## AEROSTAR SERVICE BULLETIN 130

02/20/92

**Subject:** Replacement of aluminum support tubes on Classic Limited Stretch (CWS) gondola (P/N 51620) or Classic Limited (CW) gondola (P/N 13860) or Classic Custom (CWV) gondola (P/N 15325).

**Applicability:** Aerostar S-66A (P/N 17653) or S-71A (P/N 52071) balloon systems mated to Classic Limited Stretch (CWS), Classic Limited (CW) or Classic Custom (CWV) gondolas with four point suspension and aluminum support tubes (P/N 52555-01).

# AEROSTAR INTERNATIONAL SERVICE BULLETIN 130 PROCESS FLOWCHART

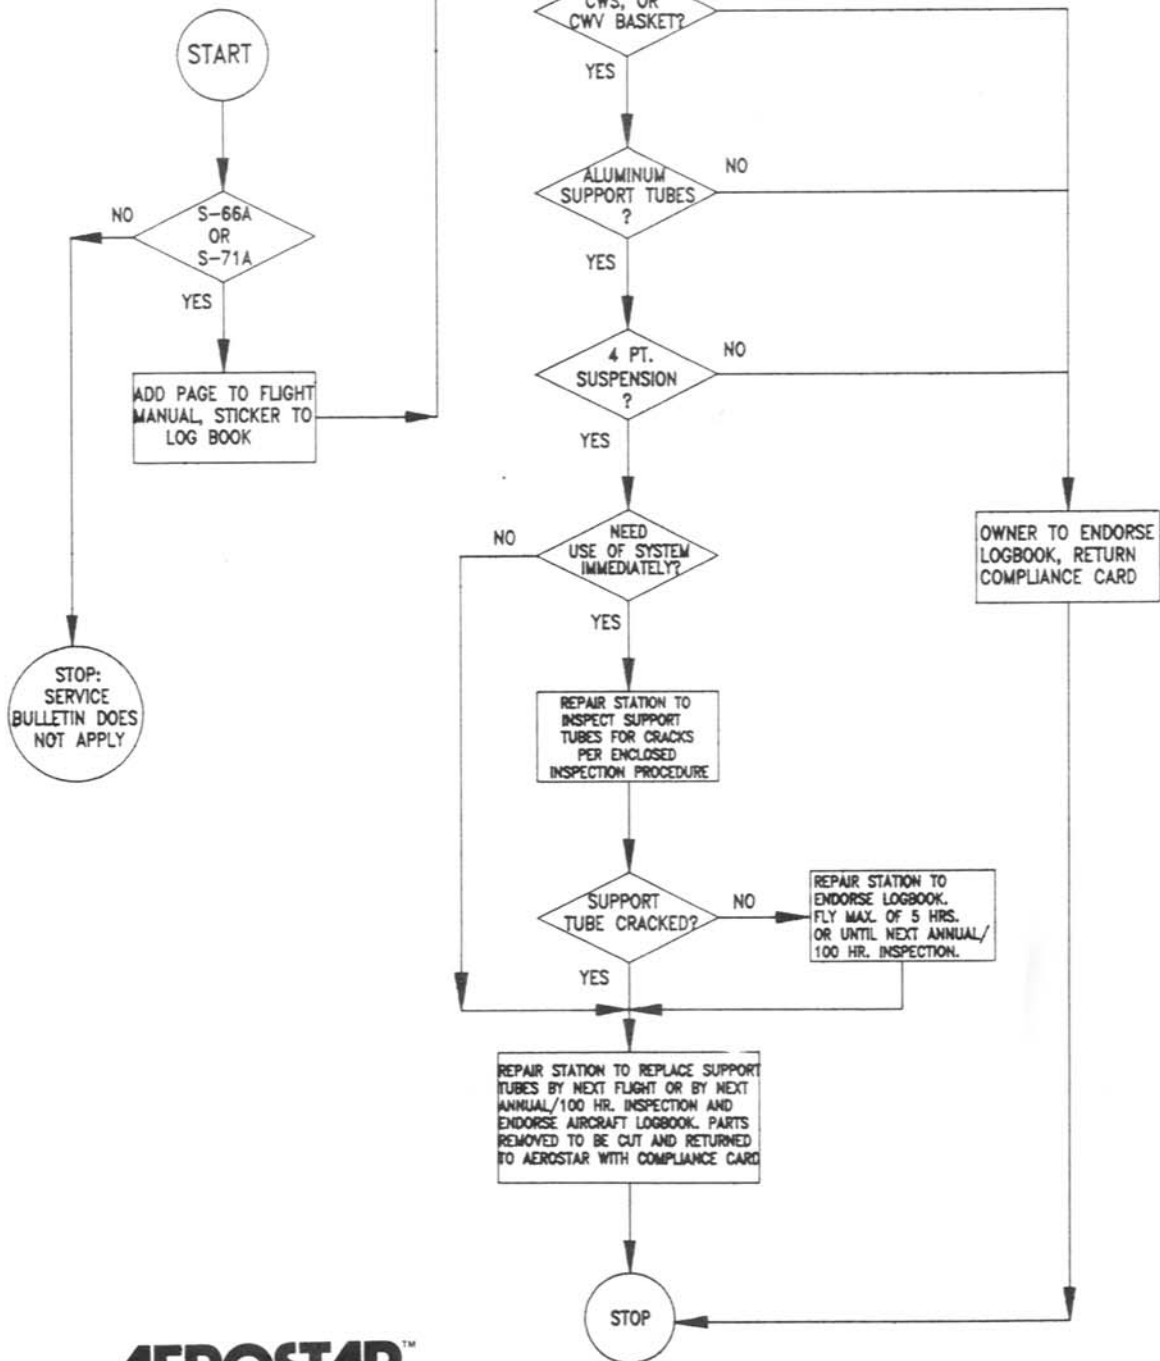
Note: See Figure 1, Page 5

- 1) Install aluminum support tubes in basket. It is imperative that the support tubes be installed in the basket to ensure a proper match and alignment of the aluminum interface pins during reassembly.
- 2) Insert quick release pins, fastening lower frames to support tubes.
- 3) Leaving quick release pins which connect basket and superstructure support tubes installed, remove bolts at bottom of support tubes. Remove support tubes from aluminum interface pins, leaving interface pins installed in lower frames.
- 4) Remove bolts which attach load blocks to aluminum support tubes (3 each load block) and remove load blocks.

- 5) Remove burner support block from aluminum support tube.
- 6) Install burner support block on stainless steel replacement support tube. Refer to P. 4-40a of ACAI manual.
- 7) Install load blocks on stainless steel support tube.
- 8) Place new support tubes on aluminum interface pins still installed in lower frames. Be sure to push support tubes down as far as possible. Install aluminum side frames, completing superstructure assembly.
- 9) Reinstall bolts connecting stainless steel support tube and aluminum interface pin.
